Application for Planning Approval

DA2025/041

MULTIPLE DWELLINGS X 2 (NDIS HIGH PHYSICAL SUPPORT HOUSING)

FURTHER INFORMATION RESPONSE AND CHANGES TO THE PROPOSAL - 20 ARBIE LANE, OLD BEACH

Drawing Title: **STORMWATER CONCEPT DESIGN SITE PLAN**

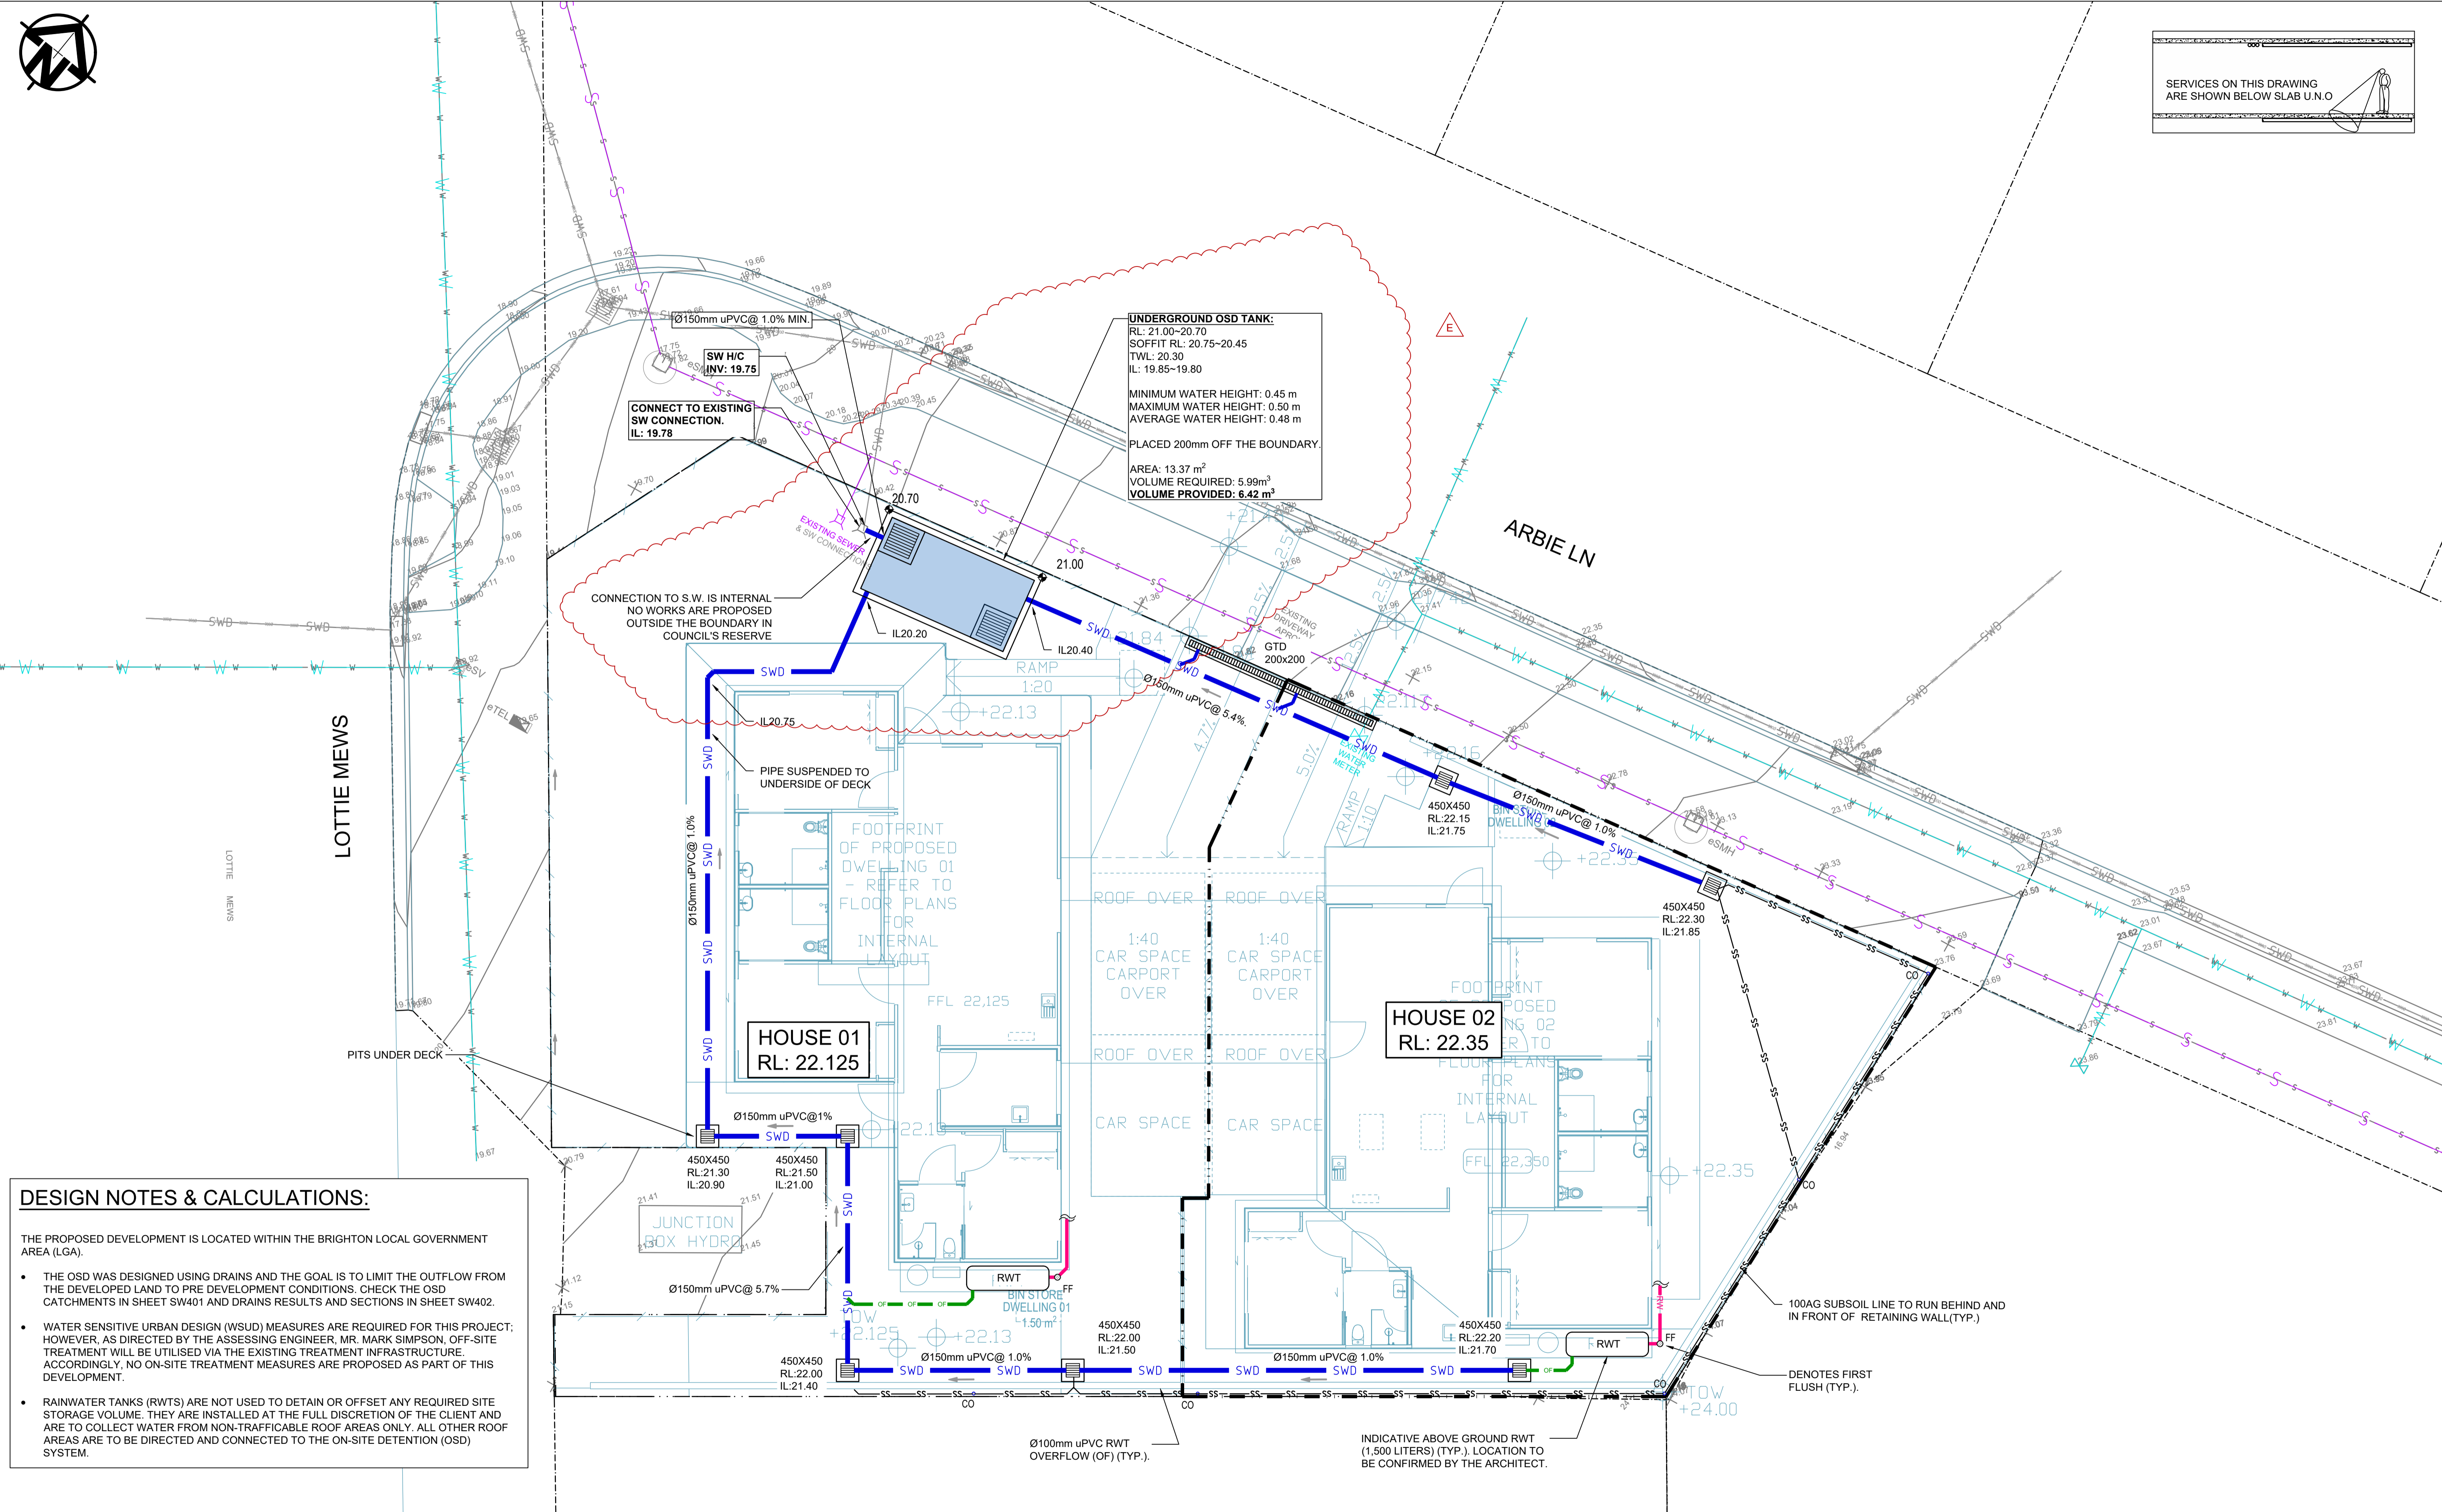
Comment: The development also requires a wider crossover and driveway, which will result in the removal and replacement of recently installed infrastructure. Council will not accept partial widening; full sections must be removed at specific panel joints with matching finishes. Asphalt repairs will also be necessary where kerb and channel replacement may cause damage. These requirements can be dealt through permit conditions.

However, to remove any doubt, we provide a revised Sheet 4 (Revision E) for the Stormwater Concept Plans prepared by SGC Consultants (October 2025) which provides for the OSD tank to be located 200mm further within the boundary of the site. This revised

plan is intended to replace Sheet 4 (Revision C) previously submitted to council as part of previous responses to further information requests.
